ADDENDUM 1

December 12, 2025

IFB #2025-01

Pictures 1-6:

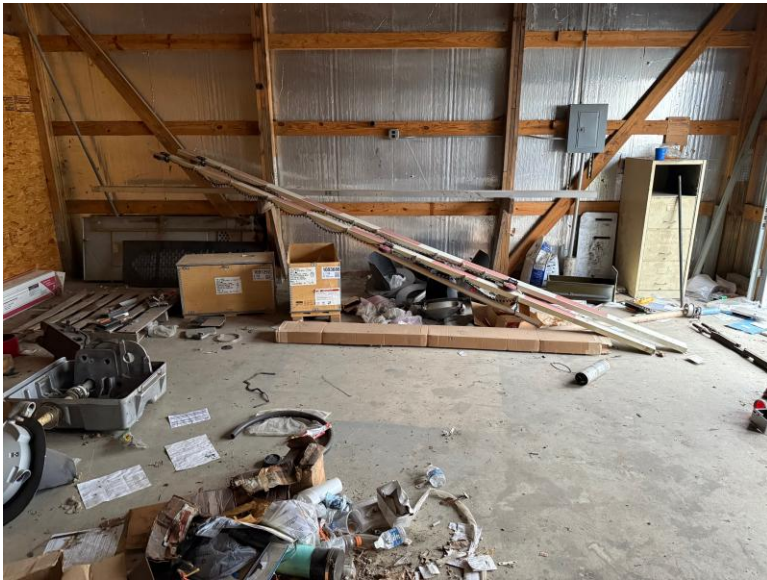
The debris in and around the shed has been identified as abandoned material by the railroad. SMTD has been in contact with an agent of the railroad police that will be available to assist if there are any issues with disposal of the materials.
